SEWAGE DISPOSAL SYSTEM

DEPARTMENT OF HEALTH AND MENTAL HYGIENE

P 47666

ADDRESS 14079 Birghton Dam Road, Clarksville, Maryland PHONE 854-2006

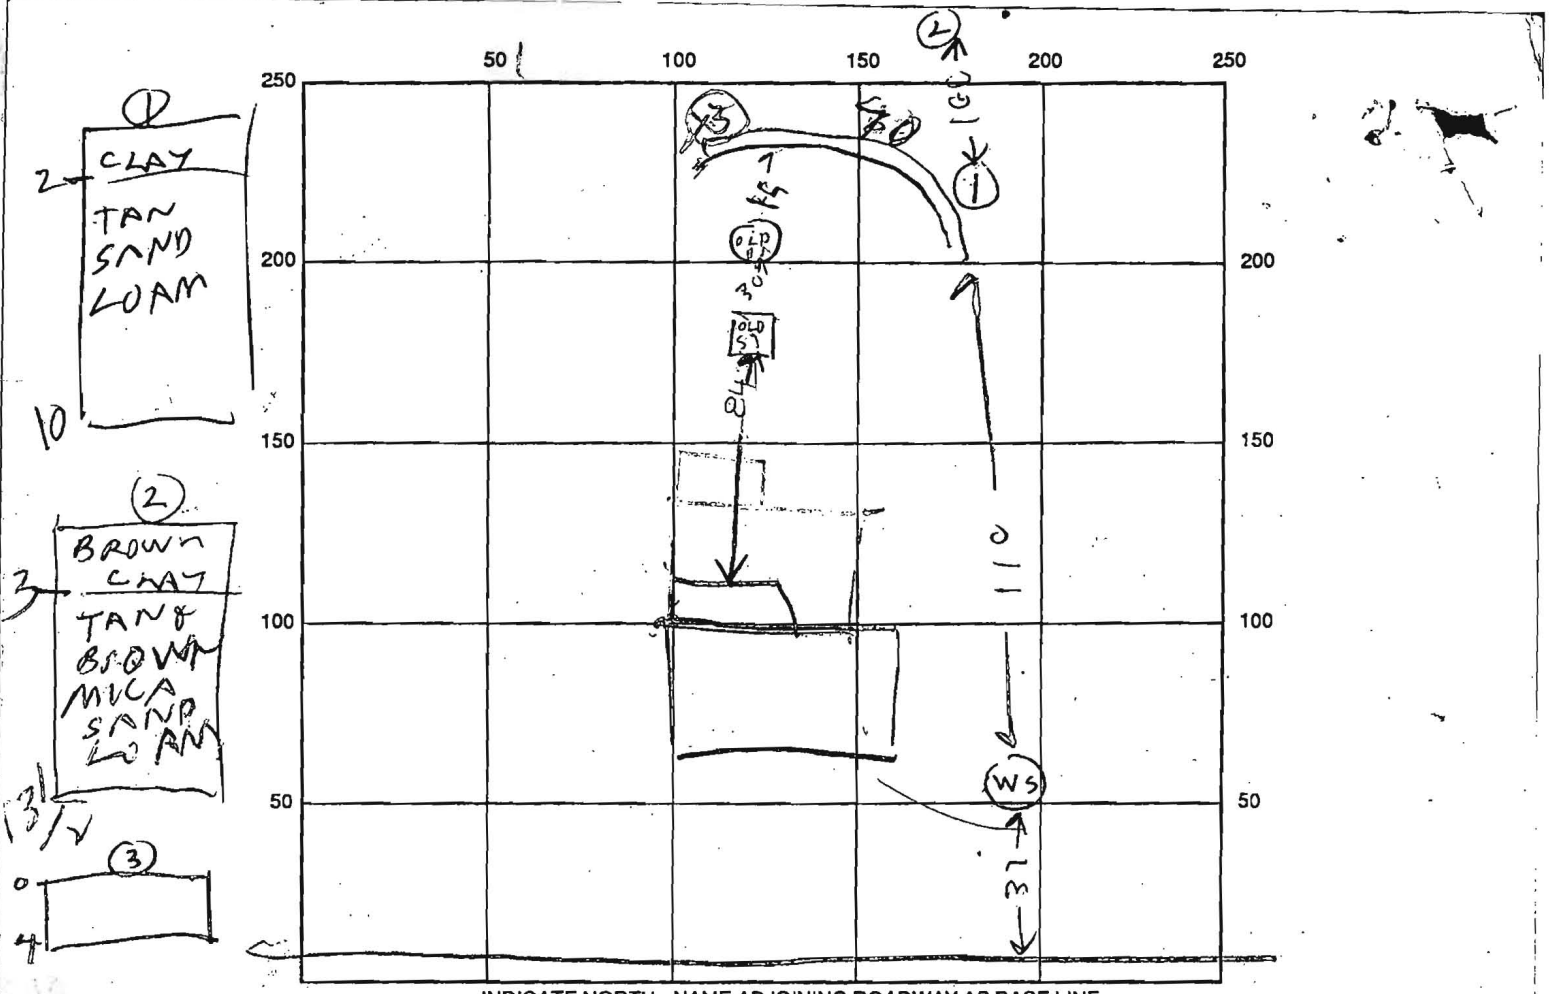
REMARKS: 12/9/91 - End of system dug open at (1) Soil OK
10 FT deep 6 FT STONE. Other end of trench dug to stone
3 ft. Grade top stone. System is adequate for 3 bedrooms
125 x 3 = 375 sq ft but a little short for 4 bedrooms
125 x 4 = 500 sq ft. Tank capacity low but some sewer
settlement in old dry well. Not sure if it is a steel
or concrete tank R.H.

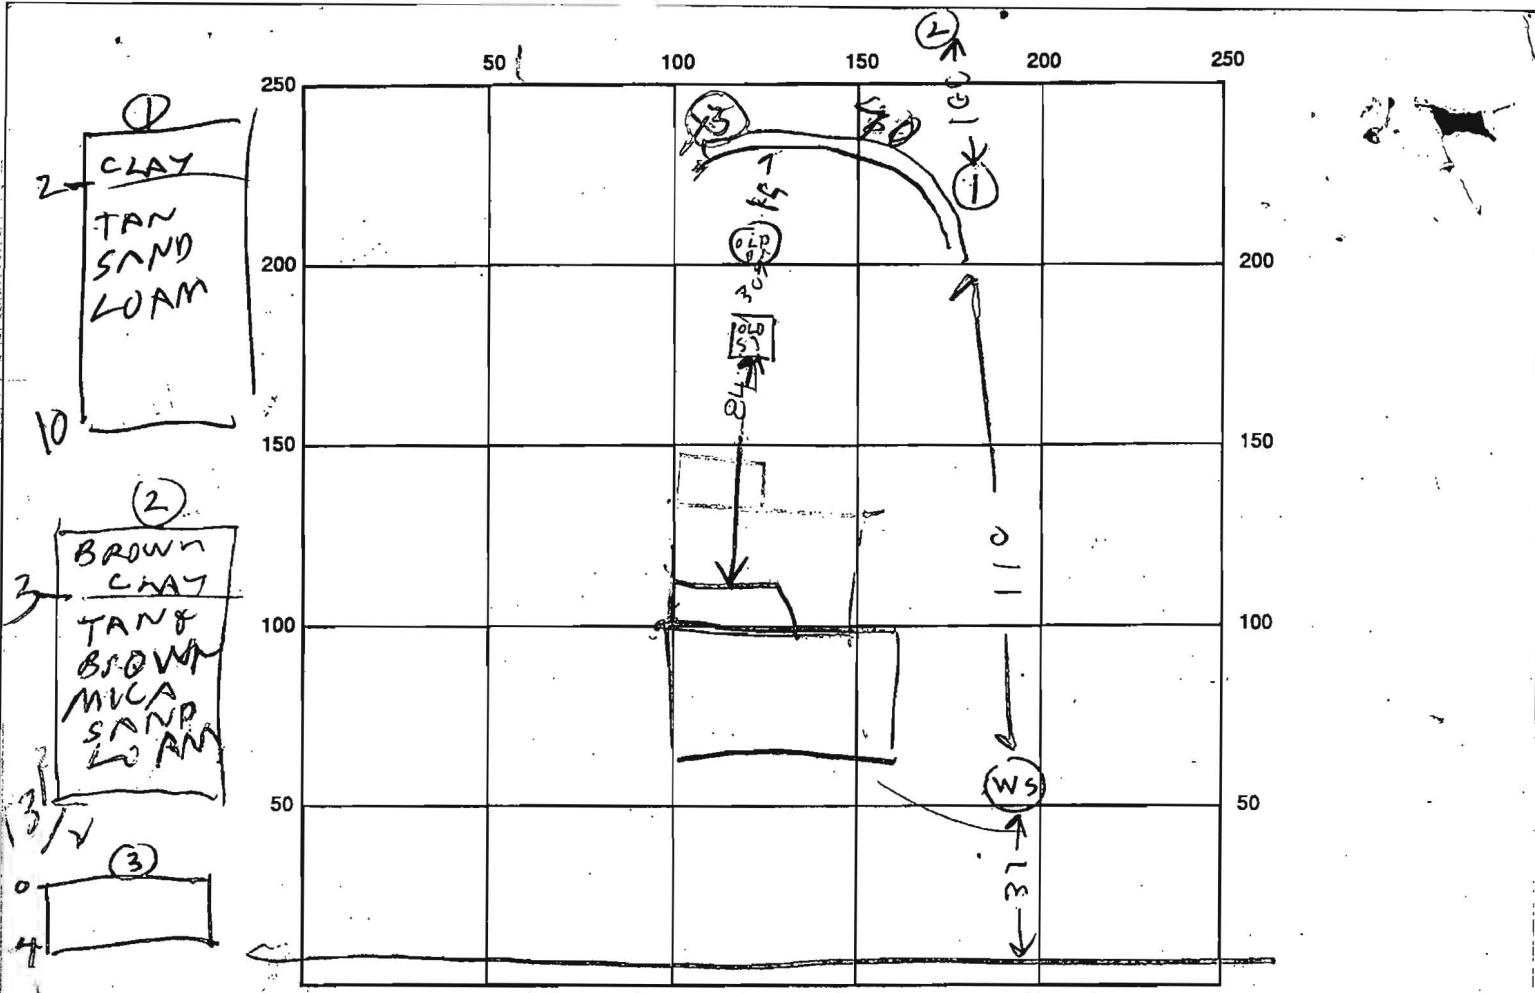
REMARKS: 12/9/91 - End of system dug open at ① Soil OK
10 FT deep 6 FT STONE. Other end of trench dug to stone
3 ft Grade to stone. System is adequate for 3 bedrooms
125 x 3 = 375 sq ft but a little short for 4 bedrooms
125 x 4 = 500 sq ft. Tank capacity low but some sewer
settlement in old dry well. Not sure abt it or a steel
or concrete tank of R N
 DATE SYSTEM APPROVED 12/9/91 INSPECTOR Raymond Hodges
